Change Order # 3 data.
Format (## / ## / ##) = (Previous page total / This Page total / Over all total)
Bid item 2: Ductile 14-16' deep: 0/0/0
Bid item 3: PVC 14-16' deep: 0/0/0
Bid item 4: CIPP: 0/389/389
Bid item 7: MH 10-12' deep: 0/0/0
Bid item 30: Inlet Protection: 0/3/3

TOWN OF LANDIS
SANITARY SEWER SYSTEM REHAB
ROWAN COUNTY, NORTH CAROLINA

SCALE: AS SHOWN
DATE: 9-22-2022
DRWN. BY: R. MOSS
CHKD. BY: G. FLOWERS
PROJECT NUMBER: G20053.0
DRAWING NO.: S-2A
SHEET NO.: 6

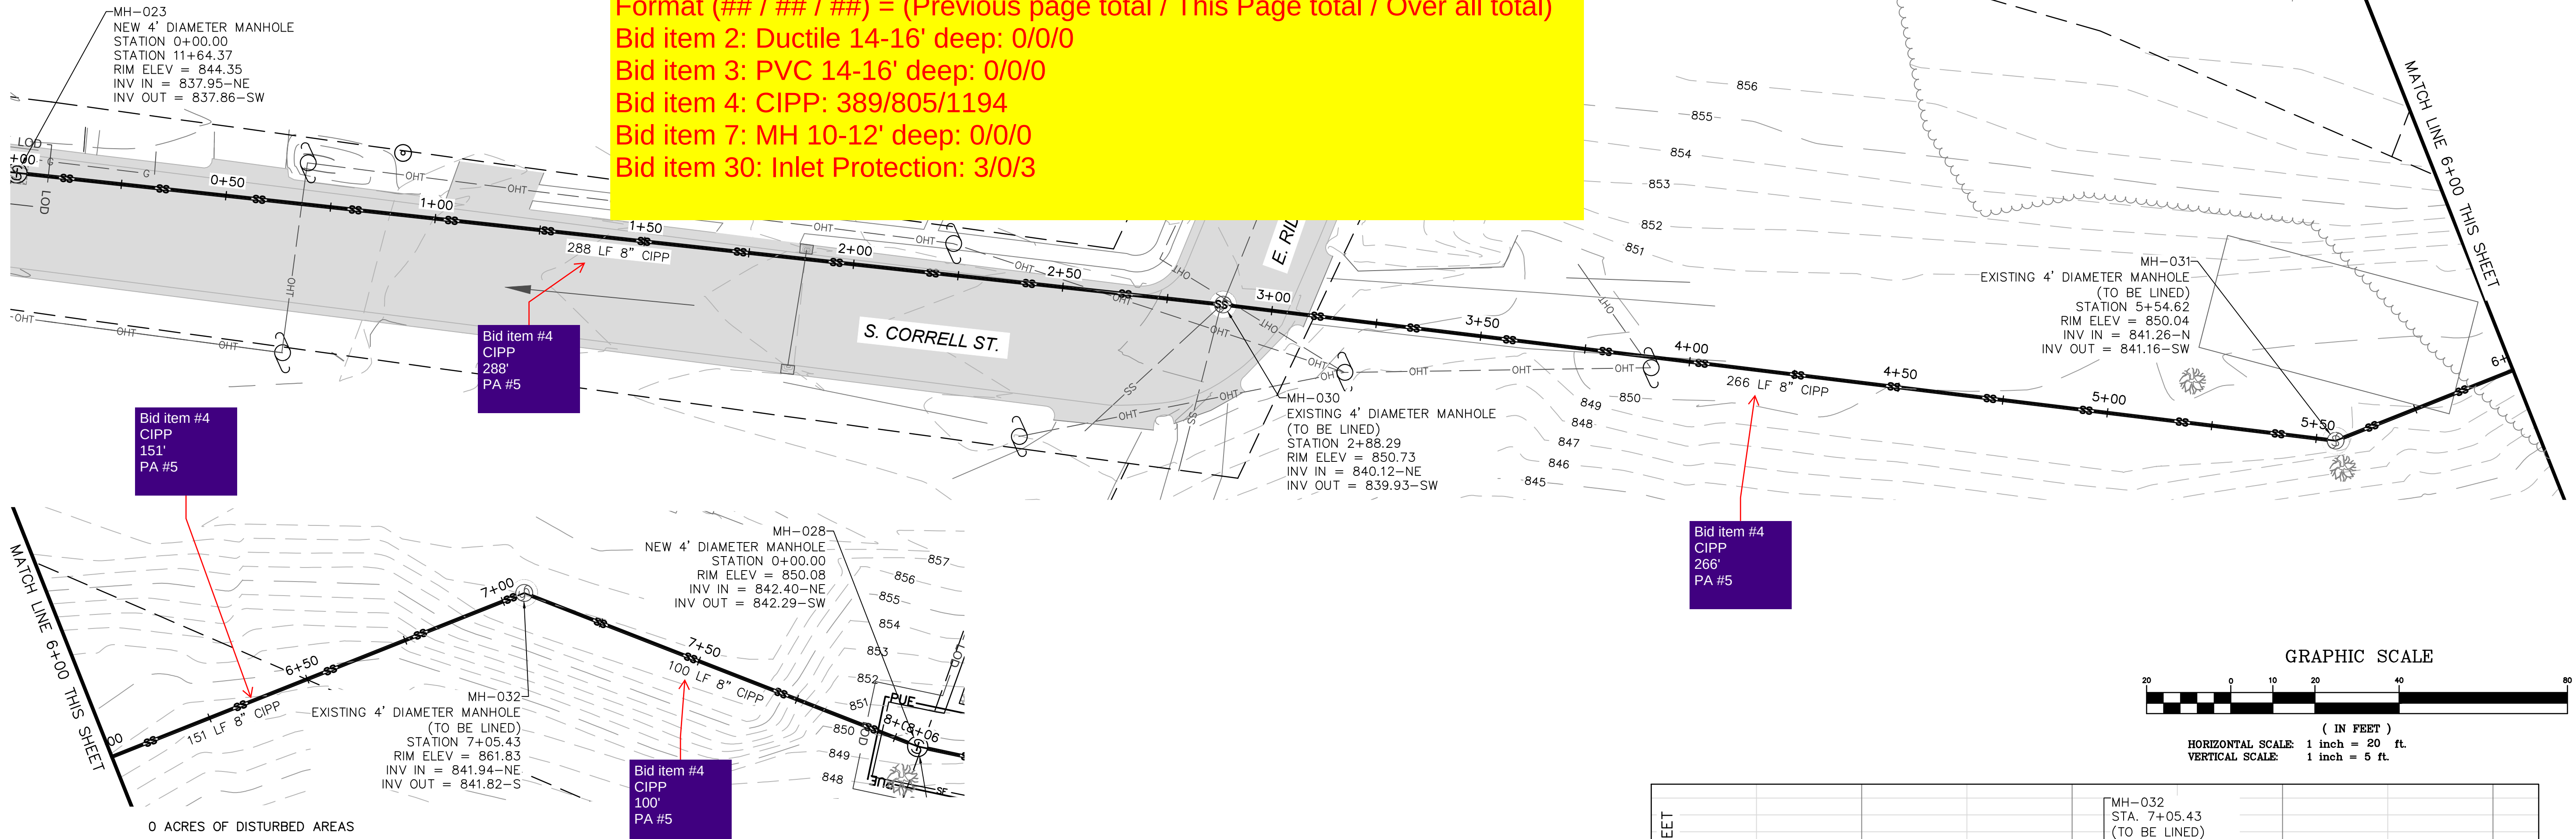
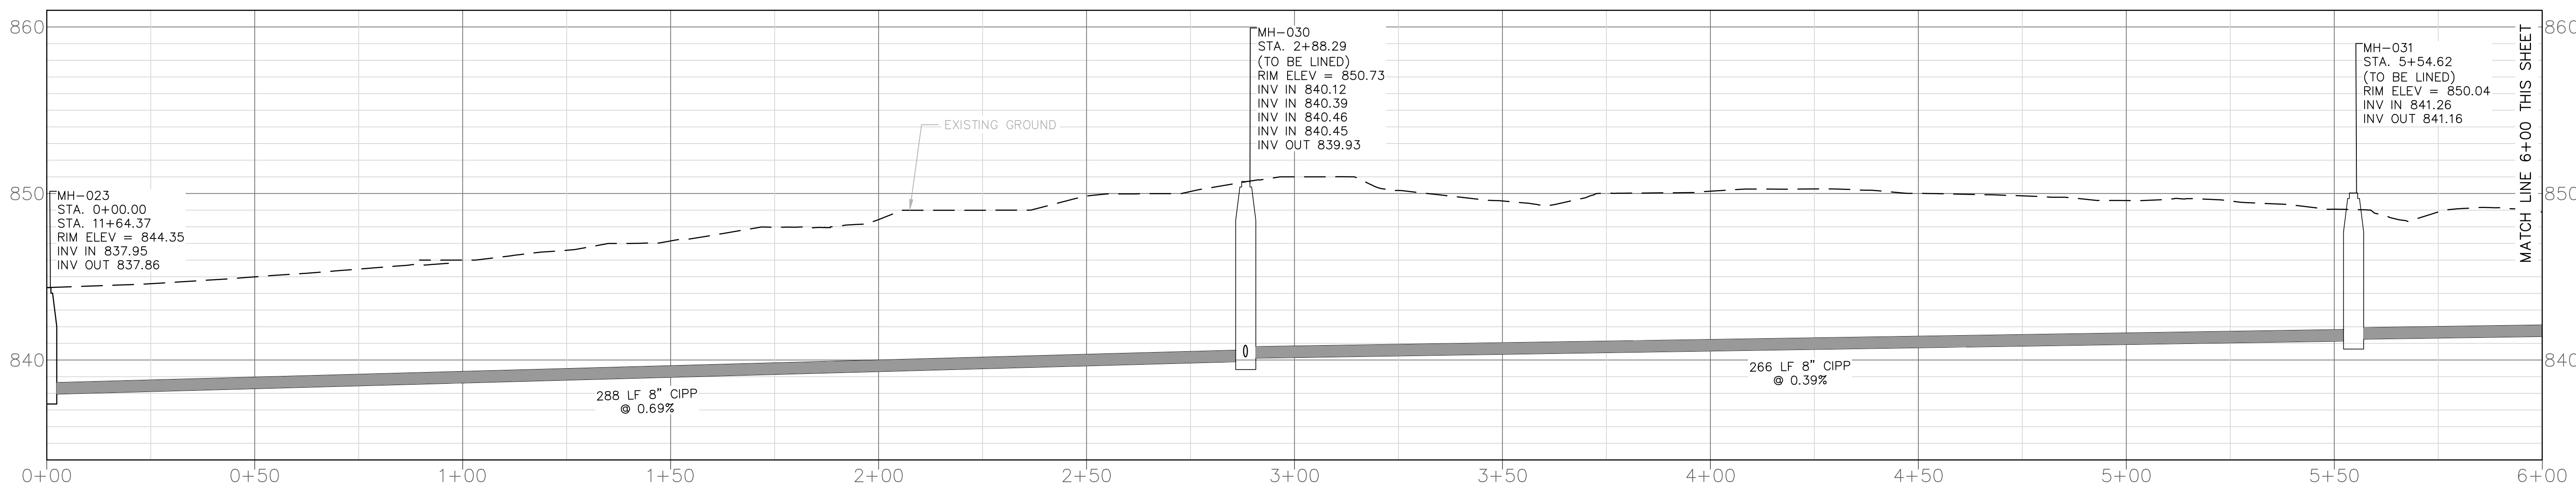
Change Order # 3 data.
Format (## / ## / ##) = (Previous page total / This Page total / Over all total)
Bid item 2: Ductile 14-16' deep: 0/0/0
Bid item 3: PVC 14-16' deep: 0/0/0
Bid item 4: CIPP: 389/805/1194
Bid item 7: MH 10-12' deep: 0/0/0
Bid item 30: Inlet Protection: 3/0/3

DATE	BY	REV.	DESCRIPTION
			PLAN AND PROFILE
SCALE: AS SHOWN			
DATE: 9-22-2022			
DRWN. BY: R. MOSS			
CHKD. BY: G. FLOWERS			
PROJECT NUMBER			
G20053.0			
DRAWING NO.		SHEET NO.	
S-3		7

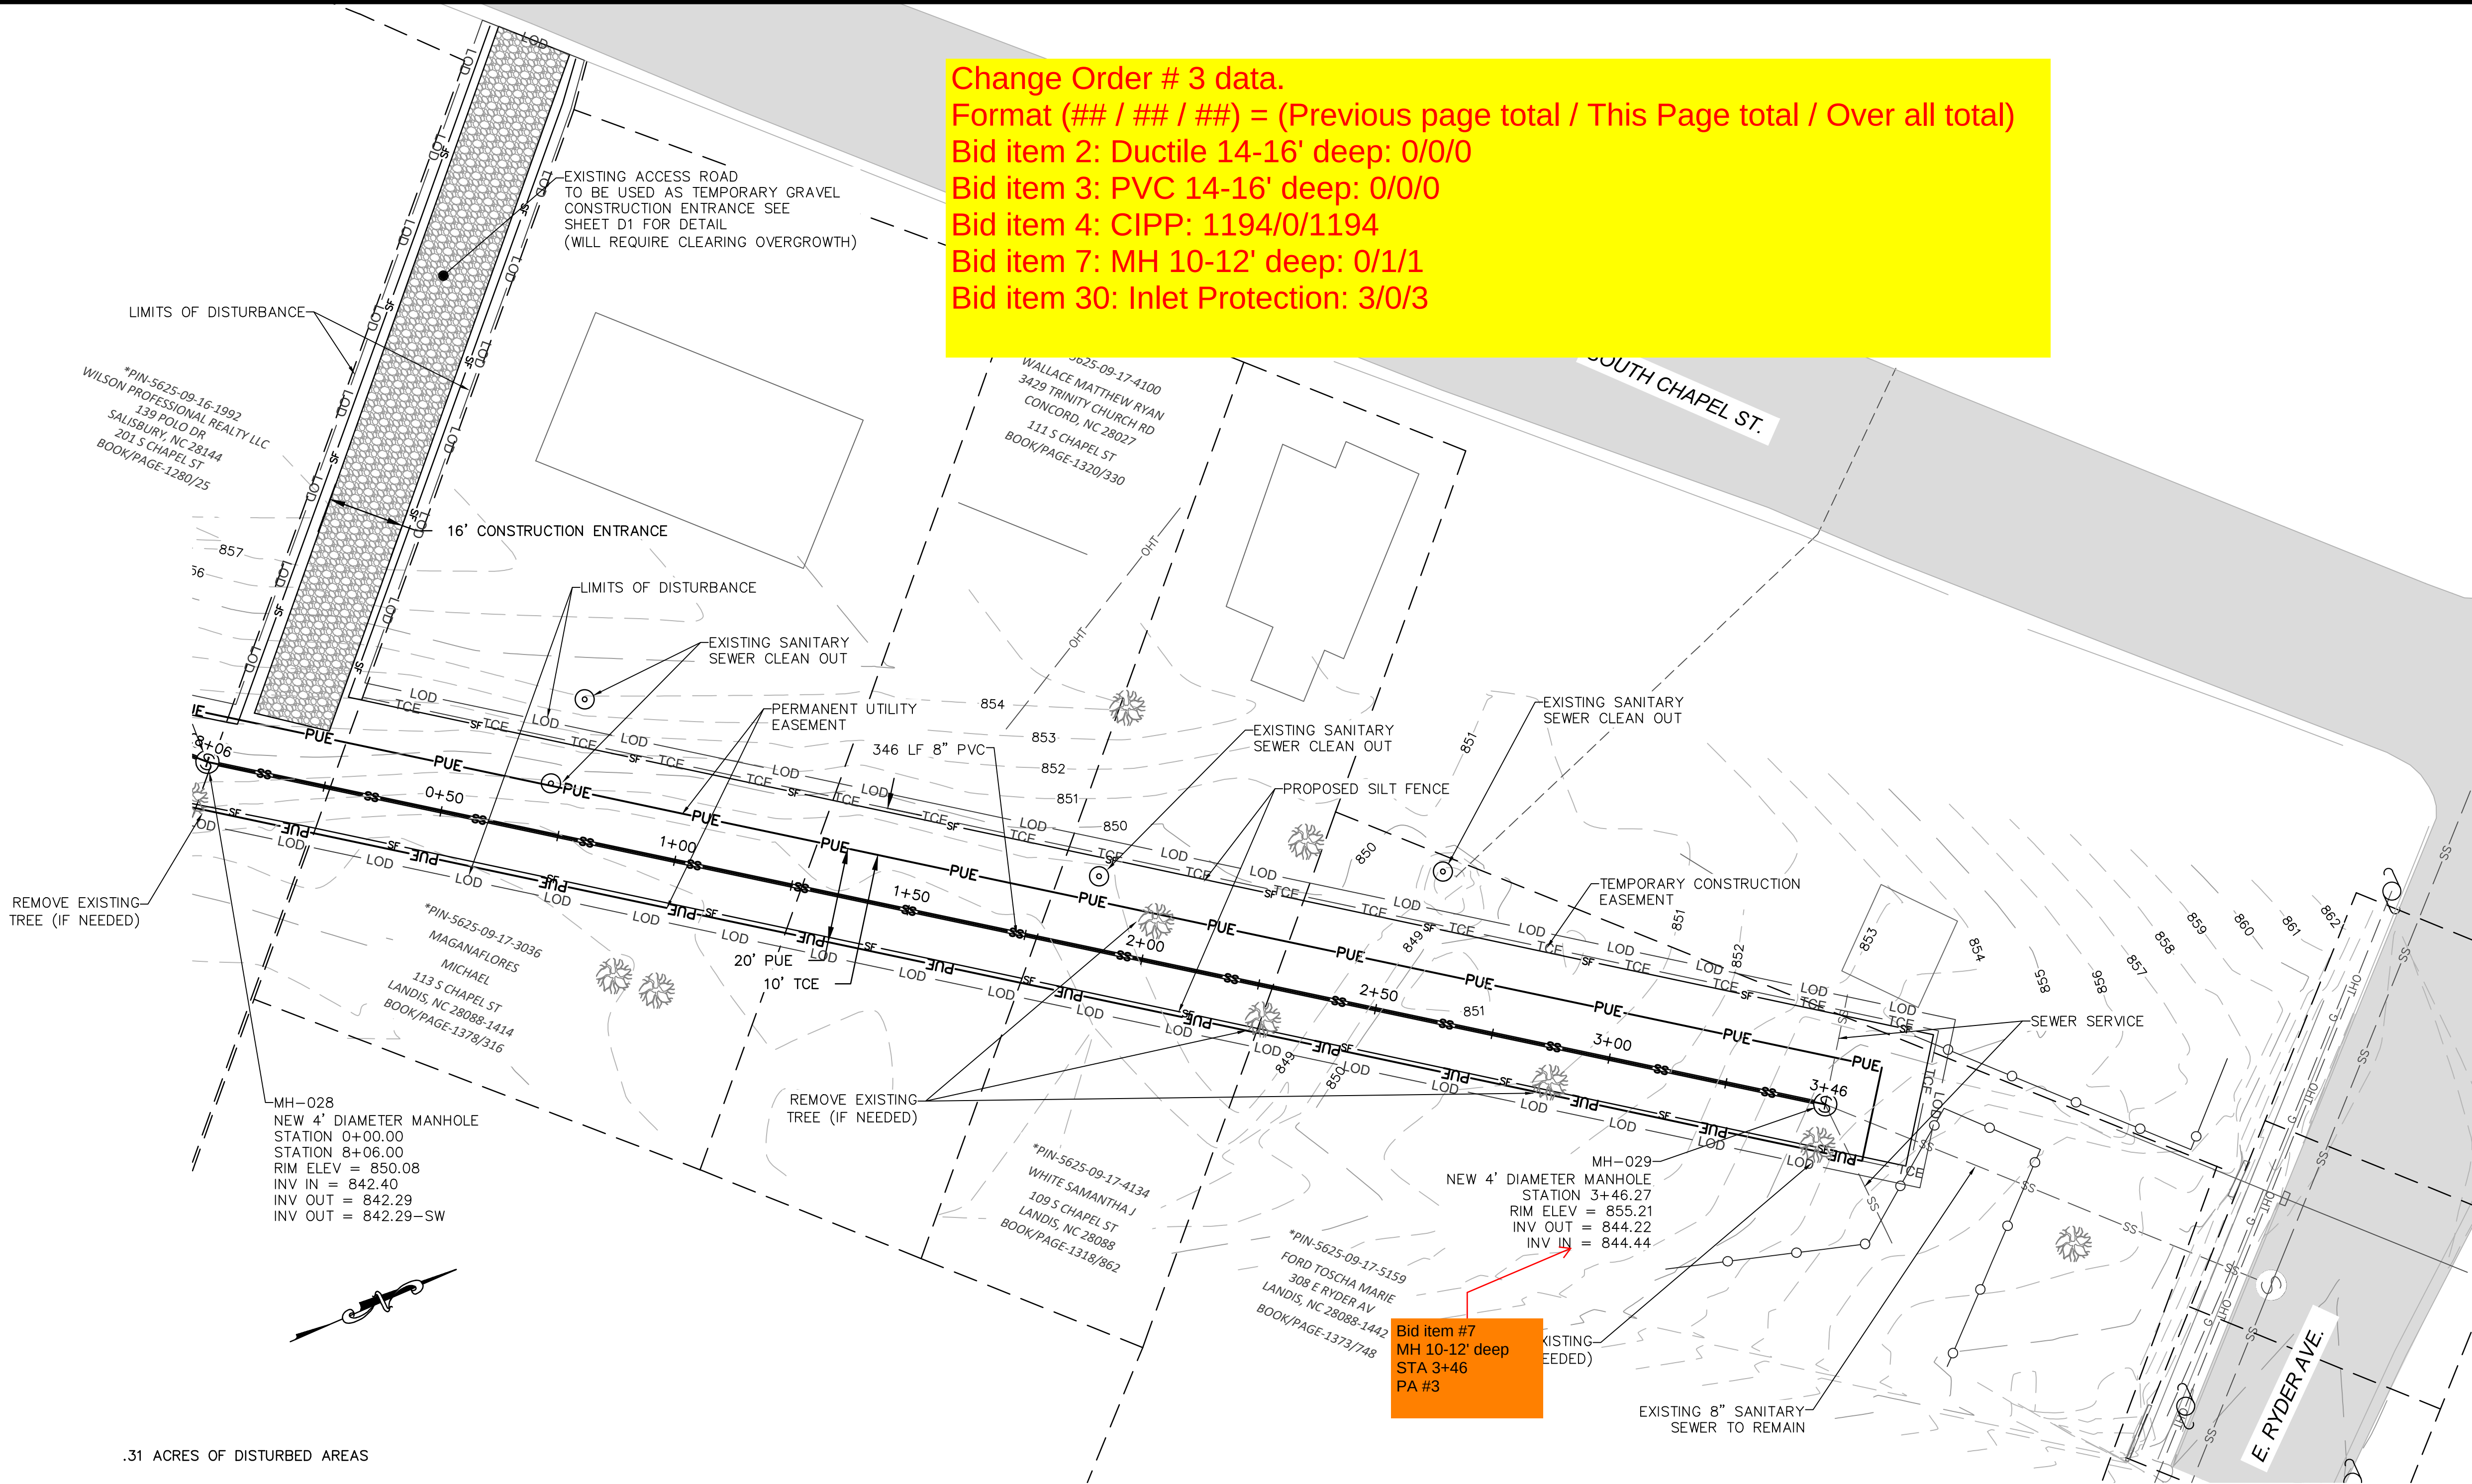
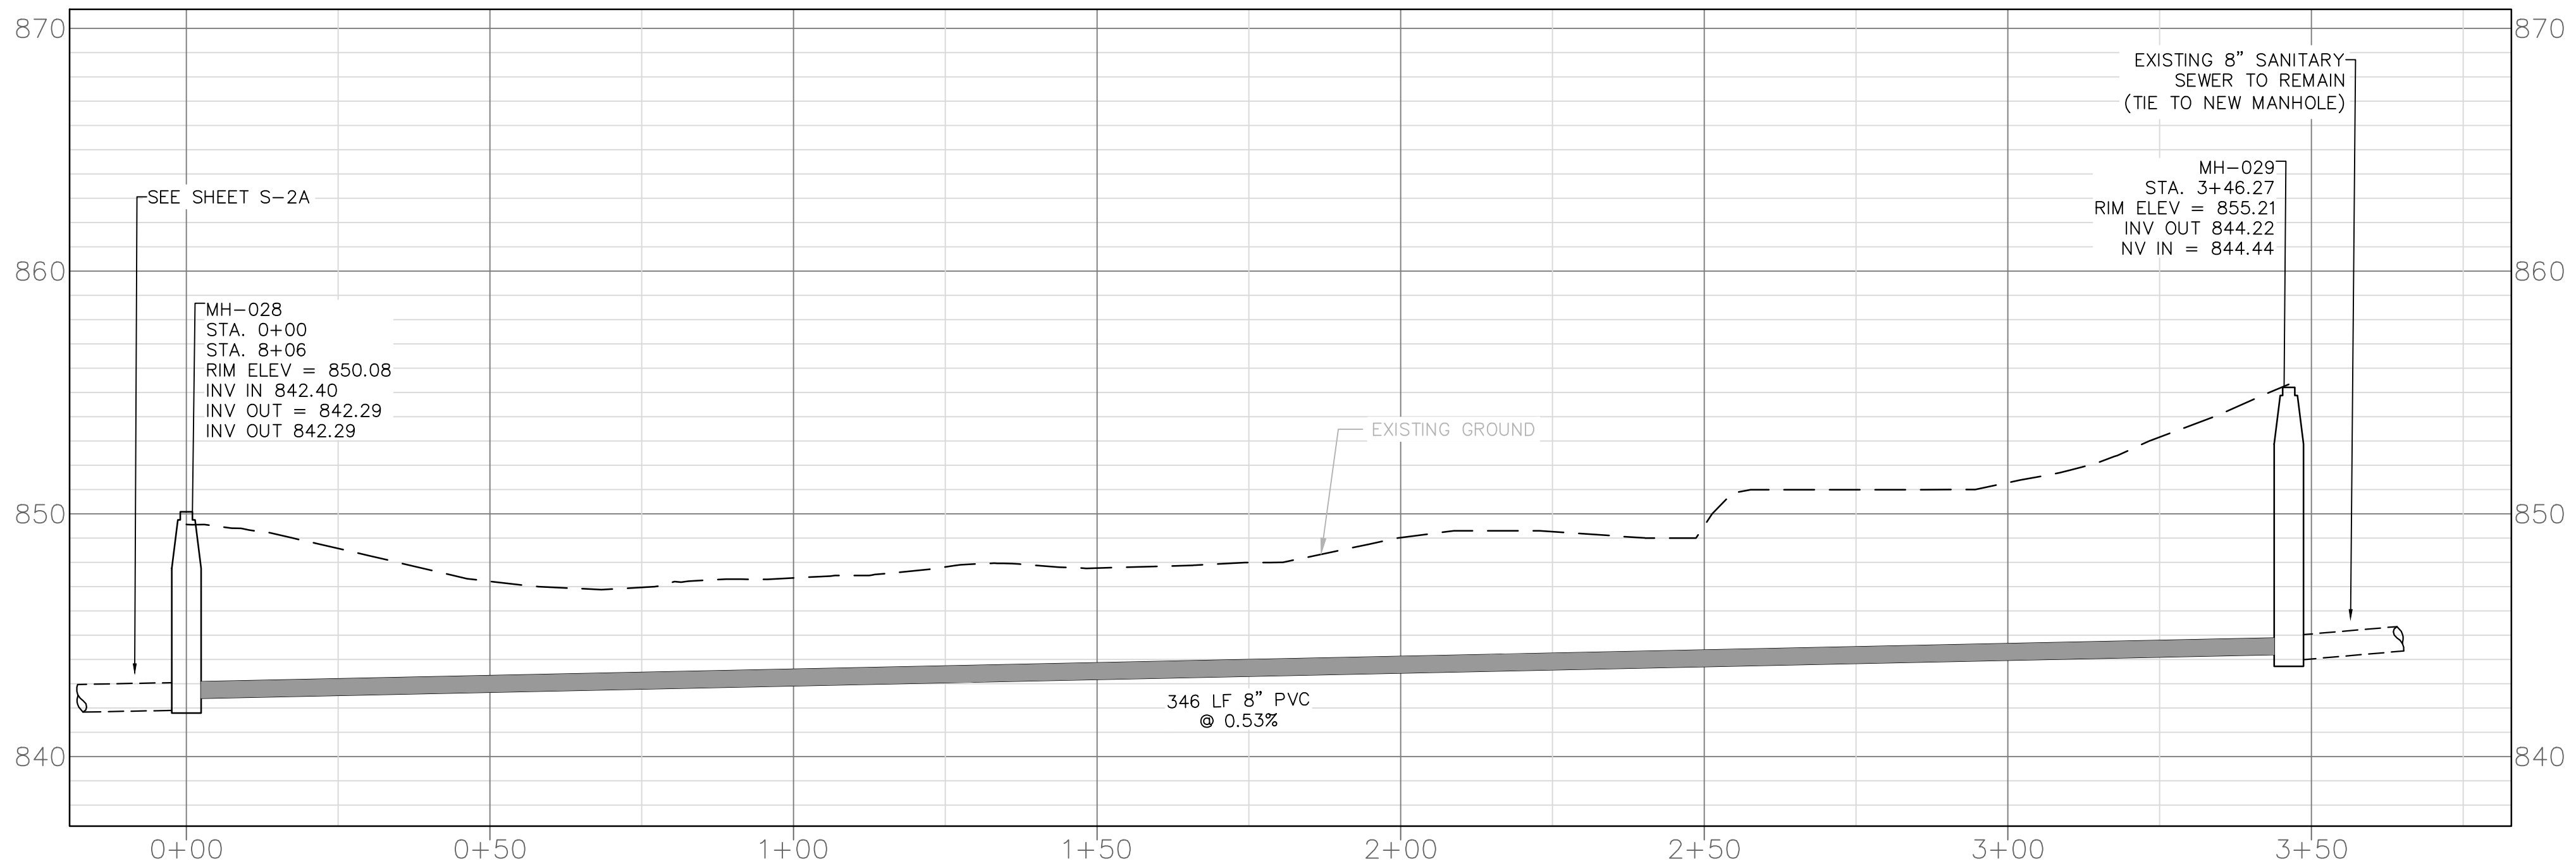
Change Order # 3 data.
Format (## / ## / ##) = (Previous page total / This Page total / Over all total)
Bid item 2: Ductile 14-16' deep: 0/0/0
Bid item 3: PVC 14-16' deep: 0/0/0
Bid item 4: CIPP: 1194/0/1194
Bid item 7: MH 10-12' deep: 0/1/1
Bid item 30: Inlet Protection: 3/0/3
